SAFETY EVALUATION BY THE OFFICE OF NUCLEAR REACTOR REGULATION

SUPPORTING AMENDMENT NO. 10 TO

FACILITY LICENSE NO. TR-2

CBS CORPORATION

FIGURE 2-13 (REV 2)

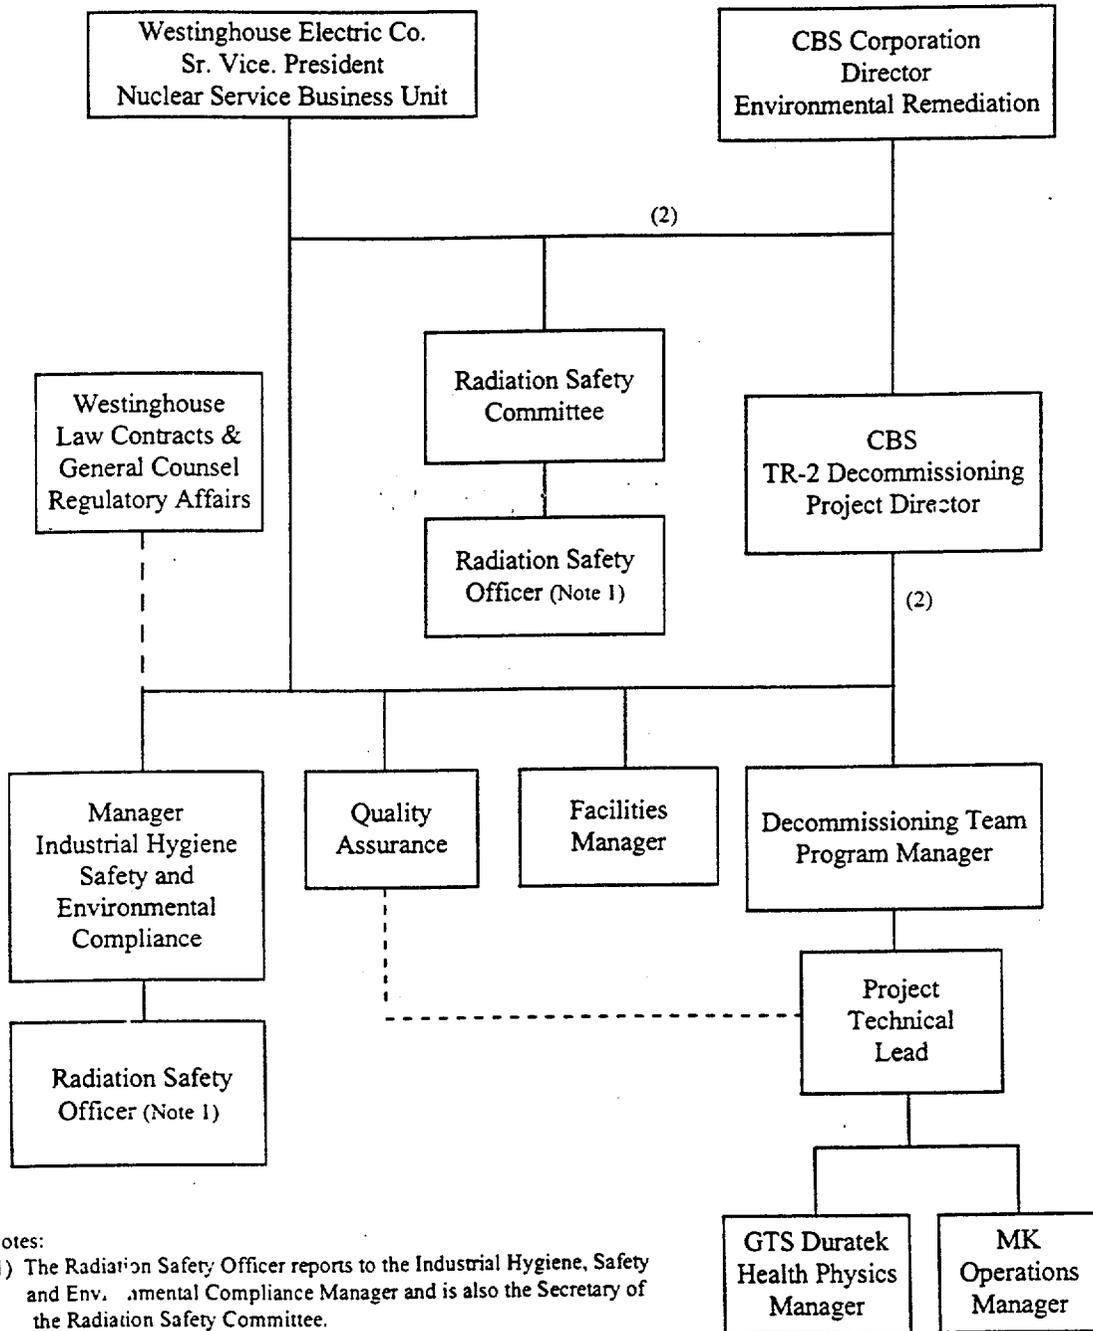
The licensee is proposing to eliminate the position of Site Manager and assign the Site Manager's responsibilities to the CBS TR-2 Decommissioning Project Director (CBS Project Director). The CBS Project Director will assume direct responsibility for operational oversight of activities conducted under the TR-2 license. The CBS Project Director will report directly to CBS's Director of Environmental Remediation. The Waltz Mill Site personnel will continue to provide support for operations, engineering, industrial hygiene, safety, security, environmental compliance, facilities and radiation protection pursuant to a contract with CBS. The Waltz Mill Site Radiation Safety Officer (RSO), who is employed by Westinghouse, will continue to provide oversight of the radiation safety program for the project. A Radiation Safety Committee (RSC), separate from the existing SNM-770 RSC, will be established to monitor decommissioning operations to ensure they are being performed safely in accordance with federal, state, and local regulatory requirements. The chairperson and members of the RSC will be appointed by CBS's Director of Environmental Remediation.

The licensee, in the letter dated September 7, 1999, has proposed to revise Section 2.4 of the Decommissioning Plan (DP) dated July 25, 1997, to show the decommissioning organization and responsibilities as they would exist under the new organization (Attachment 1). Also, a revised organization chart submitted in a letter dated October 1, 1999, (Attachment 2) supersedes the chart on page 2-46 of the July 25, 1997 DP.

The staff finds all the above changes acceptable.
